Council Detailed Assessment 21 July 2026

SSD-87033962 - Mixed use development and amendments to Willoughby LEP 2012 815 Pacific Highway, Chatswood

Figure 41: Site Layout

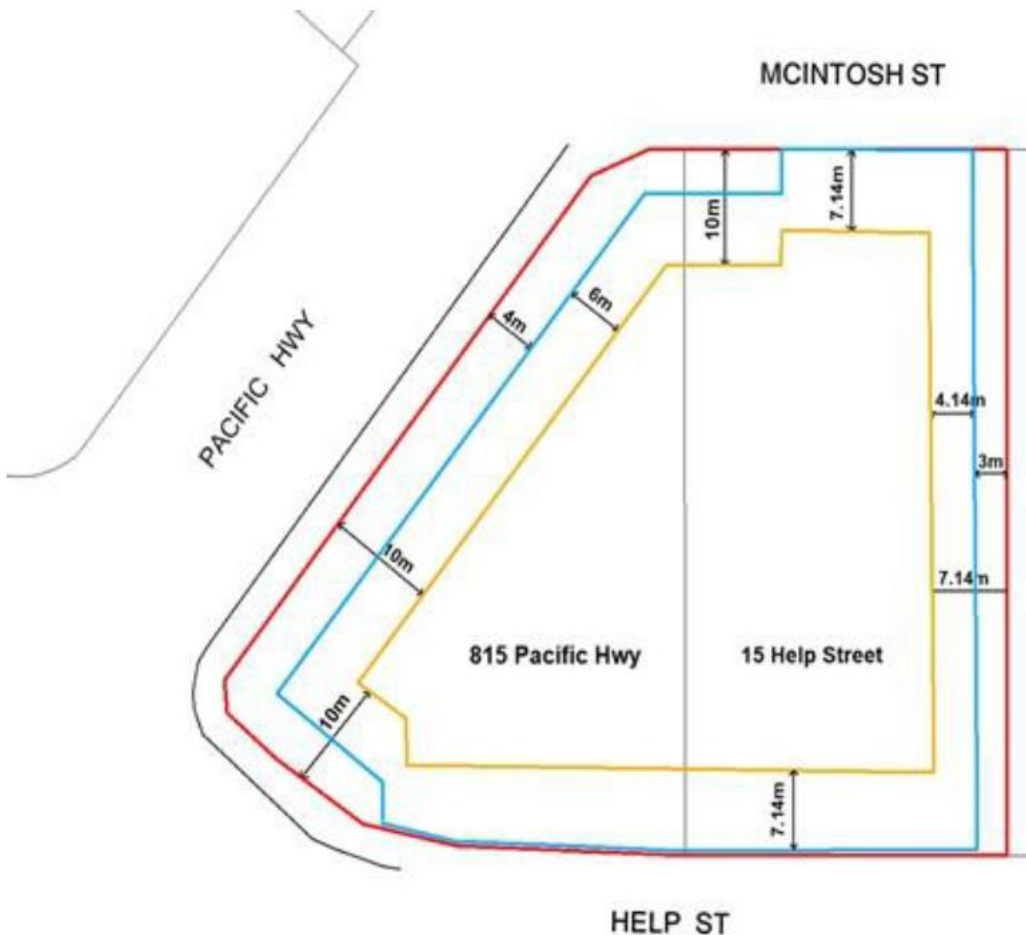
The proposed SSDA podium is inconsistent with the approach specified in the DCP, and with recent approvals on the Pacific Highway. The Pacific Highway setback of the tower from the podium is 2.047m, which begins at 12 storeys and continues up to 61 storeys. A WDCP compliant tower setback would be 10m. There are also encroachments into the Pacific Highway setback by the podium (being 0.950m to the boundary) and the tower (being 2.047m from the boundary (tower)).

The setback and podium issues prevent the development from achieving the desired slender tower form and a site layout that enhances adjoining public spaces, enhances visual and acoustic privacy, natural ventilation, sun access and views and provides suitable areas for deep soil zones, landscaping and public domain embellishment. It is also unclear how significant canopy planting is to be achieved within the Pacific Highway setback.

The proposed built form should be significantly revised with more appropriate setbacks to reduce the bulk and scale of the building.
